City of
Richmond

Report to Development Permit Panel

File: DP 17-791769

Re: **Application by Polygon Berkeley House Ltd. for a Development Permit at
9211/9251/9271/9291 Odlin Road**

A-2.00
Plan #5

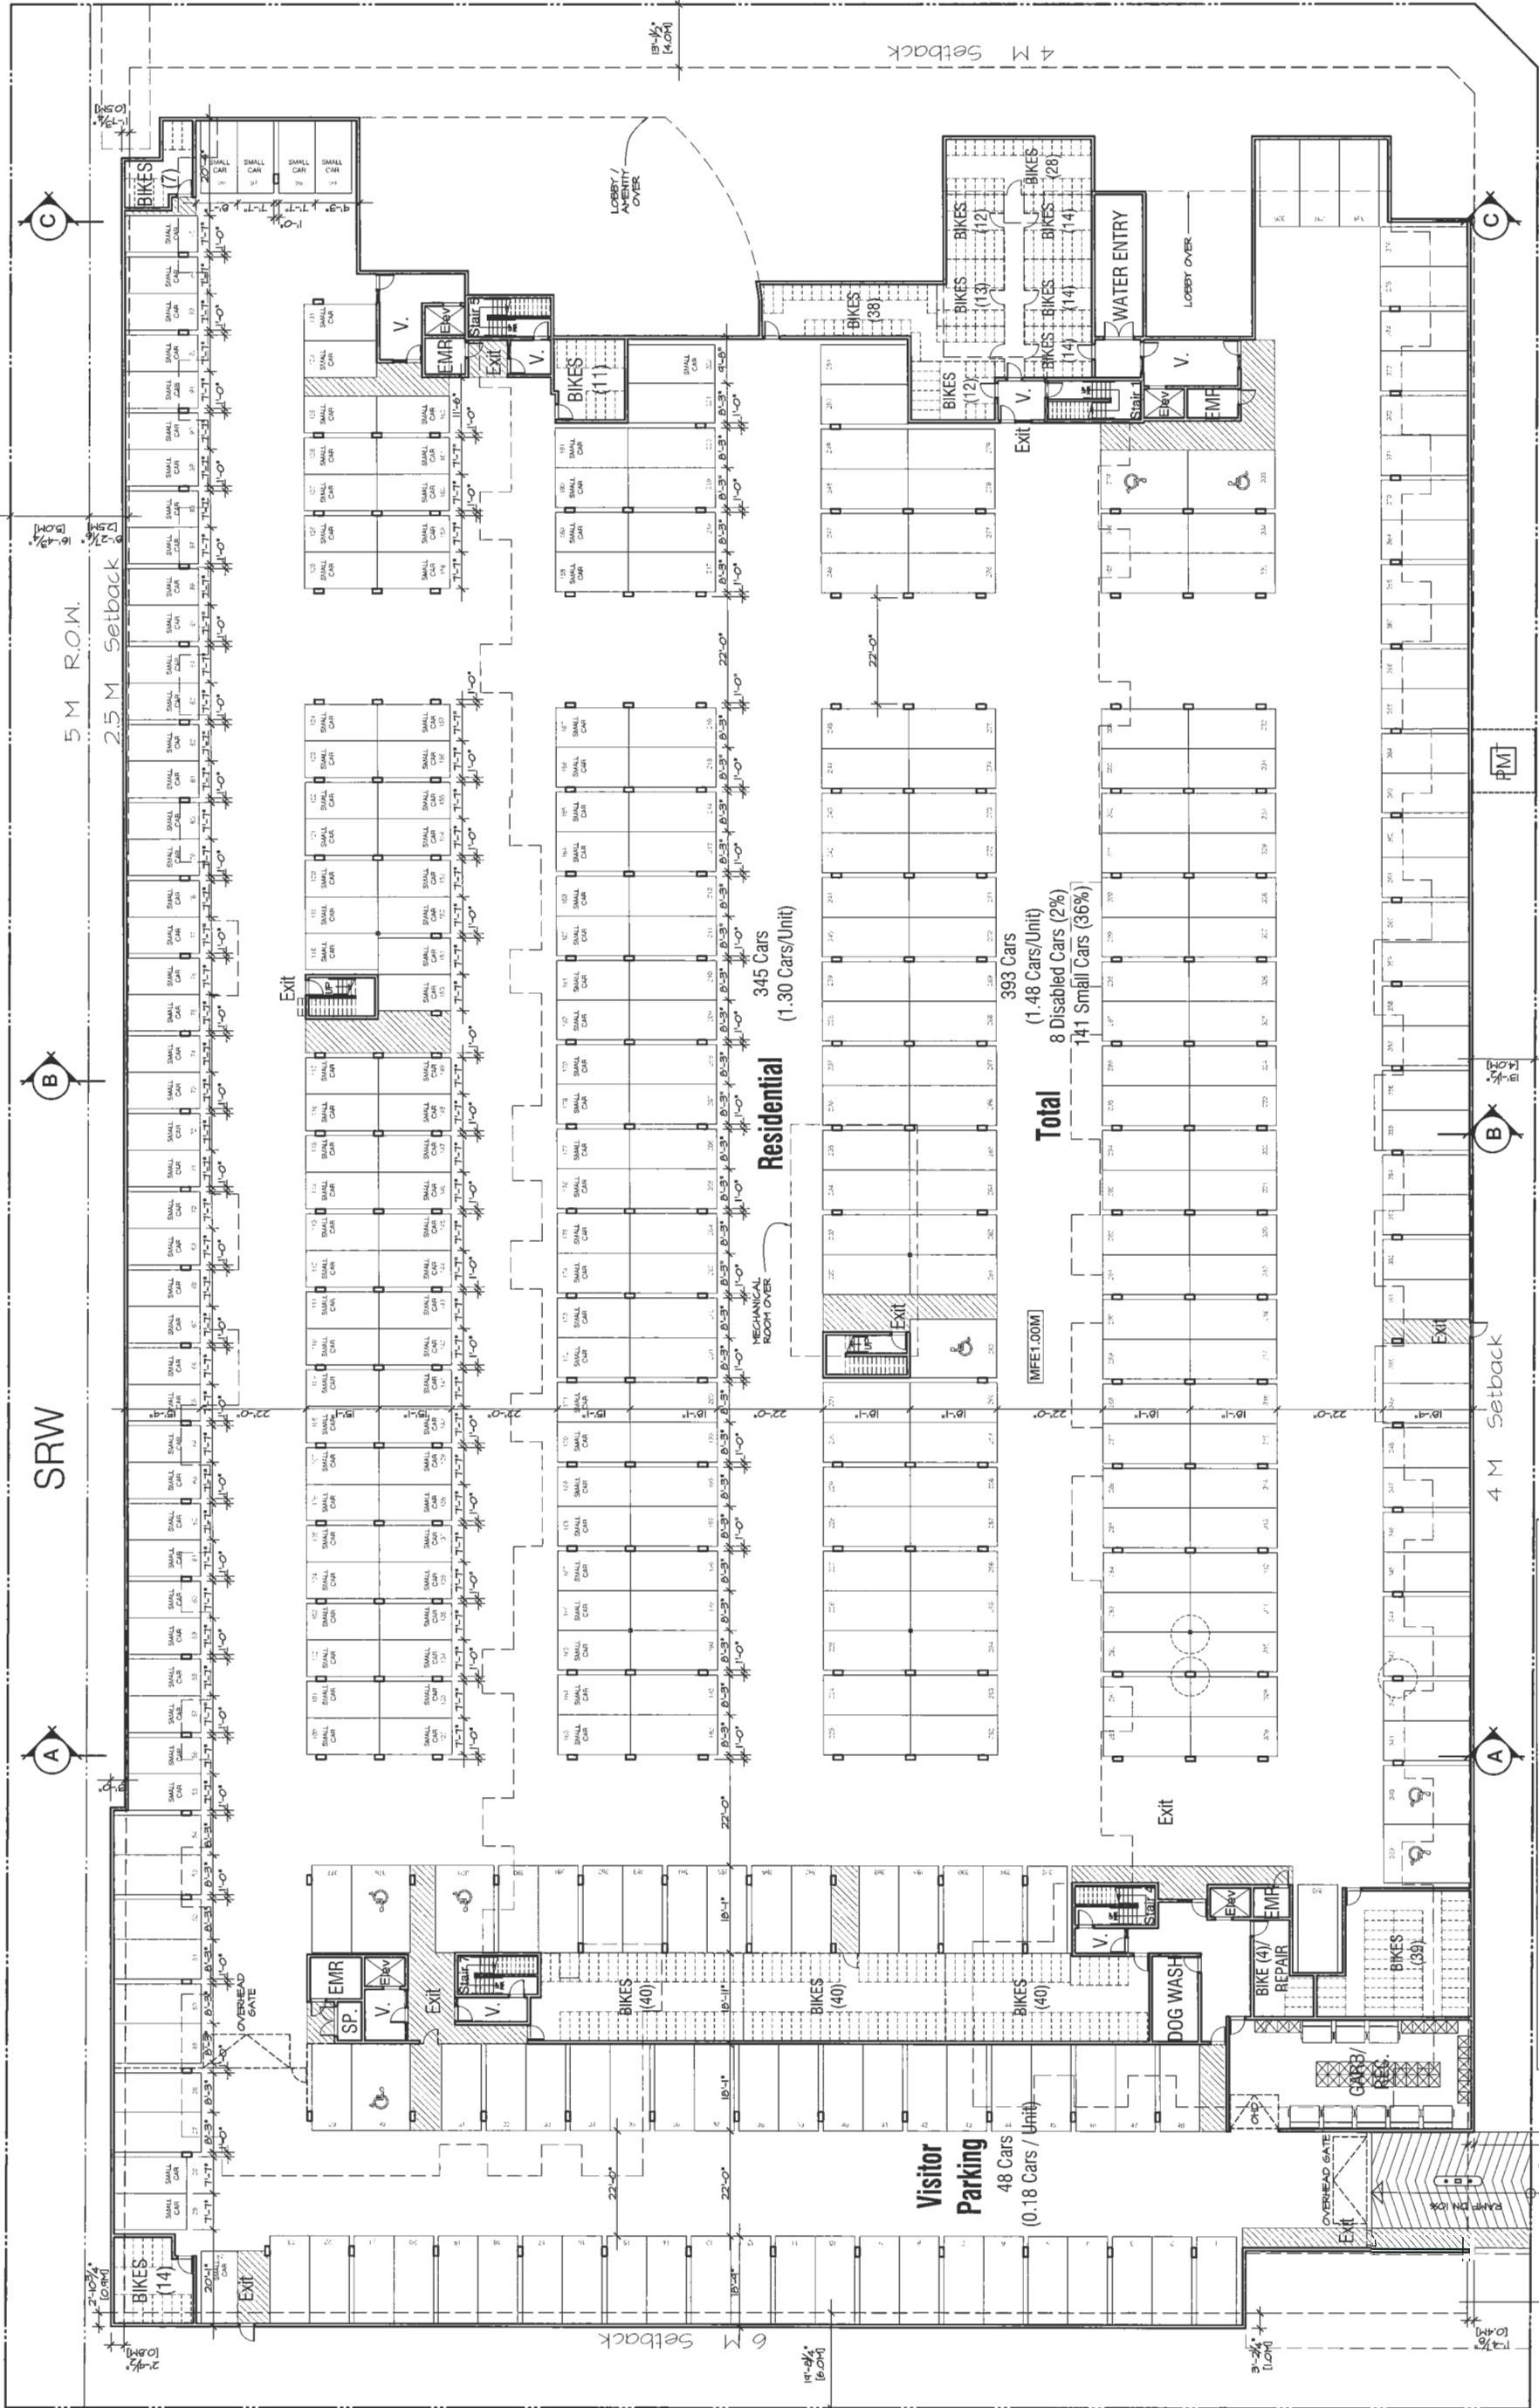
- Refine the garbage/recycling loading area.
(The Overall Parking Plan now includes the layout for the garbage and recycling area accommodating the required number of bins.)
